Product/Process Change Notice - PCN 22_0226 Rev. -

PCN Title: ADRF5024 Data Sheet Revision

Data Sheet Revision for ADRF5024:

Low Frequency Power Handling for 'Input at RFC' and 'Input at RFx' in Data Sheet Rev. D

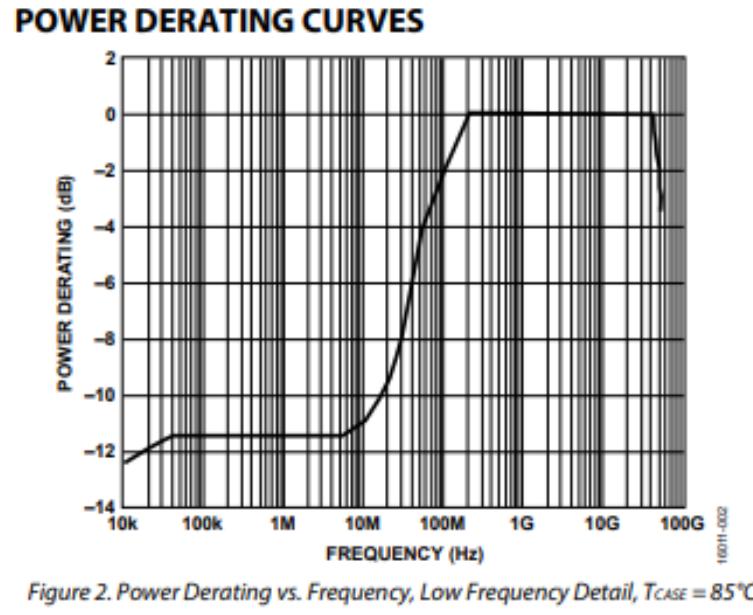
1. Recommended power handling for 'Input at RFx' case added to Table 1.
2. AMR power handling for 'Input at RFx' case added to Table 2.
3. Power derating curve for low frequency (Figure 2) updated.

Values corrected to reflect actual recommendation and part performance.
